PLANNING & ZONING COMMISSION STAFF REPORT

Public Hearing Date: August 12, 2026
Subject: Case No. SIT-2026-0083
Applicant/Owner: Christus Health
Case Manager: Danyelle Valdez, Planning Manager

CASE NO. SIT-2026-0075: Christus Health requests approval of a Site Plan Adoption for the construction of a 37,277-square-foot, two-story medical facility on the approximately 1.64-acre property located at 401 Trinity Drive, zoned General Commercial (GC).

Figure 3: Utilities & Drainage Easements

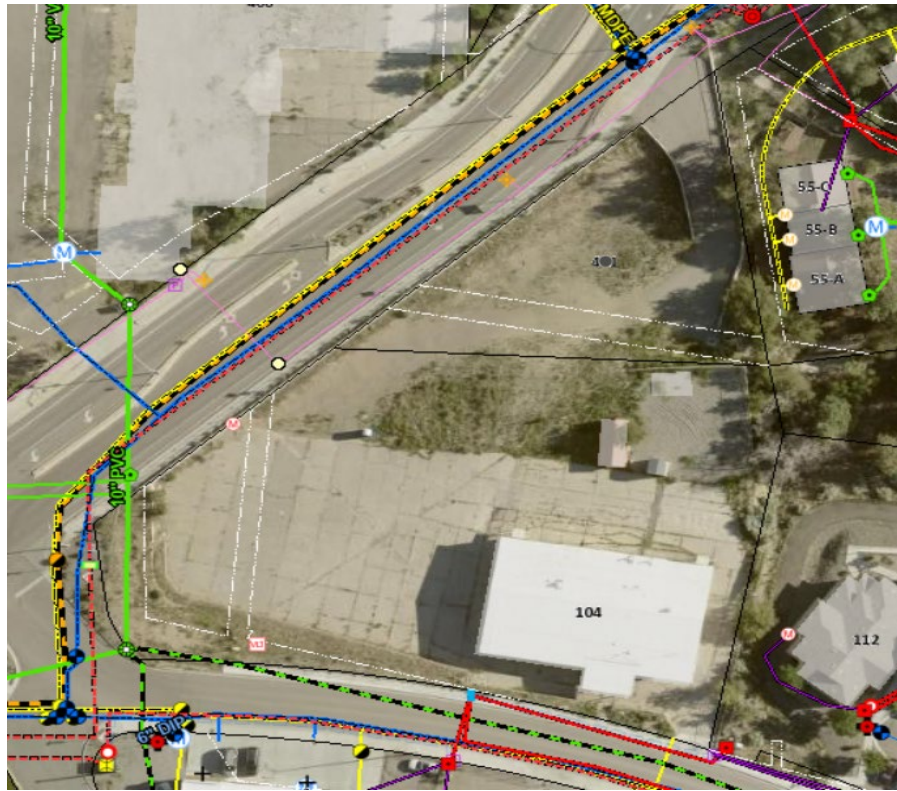
DPU reviewed the site plan application and provided technical comments and conditions applicable to the permit documents. The applicant must provide a joint utility trench cross-section showing an approved staggered layout consistent with the applicable DPU Construction Standards Drawing; identify the proposed gas-line size and physical location of the gas meter; revise the fire hydrant and hydrant-leg details to conform to the applicable Los Alamos County standard detail; and provide a connection detail for the existing sewer manhole.

- Identify the new on-site storm sewer system as privately owned and maintained and specify that the associated manhole covers shall be marked accordingly.
- Replace the existing storm drainpipe traversing the property and adjust its installation depth to accommodate the significantly higher proposed grades. The replacement shall be coordinated with Public Works and addressed in the drainage assessment.
- Depict the proposed stormwater flow patterns on the grading and drainage plan.

1. Prior to submitting any associated permit applications, the applicant shall revise the applicable drawing sheets to: (1) provide a joint utility trench cross-section showing an approved staggered layout consistent with the applicable Department of Public Utilities Construction Standards

Drawing; (2) identify the size of the proposed gas line and the physical location of the gas meter; (3) revise the fire hydrant and hydrant-leg details to conform to the applicable Los Alamos County standard detail; and (4) provide a connection detail for the existing sewer manhole. The corrected drawing sheets shall be submitted directly to the Department of Public Utilities for final review and verification.

4. Prior to issuance of a building permit, the applicant shall submit a drainage assessment demonstrating that the proposed development will not increase off-site stormwater flows beyond existing conditions. The assessment shall include pre- and post-development 100-year storm-flow calculations, supporting methodology, and documentation demonstrating that the existing and proposed stormwater systems can adequately convey post-development flows. The assessment shall also address replacement of the existing storm drainpipe traversing the property and adjustment of its installation depth, in coordination with the Los Alamos County Public Works Department.
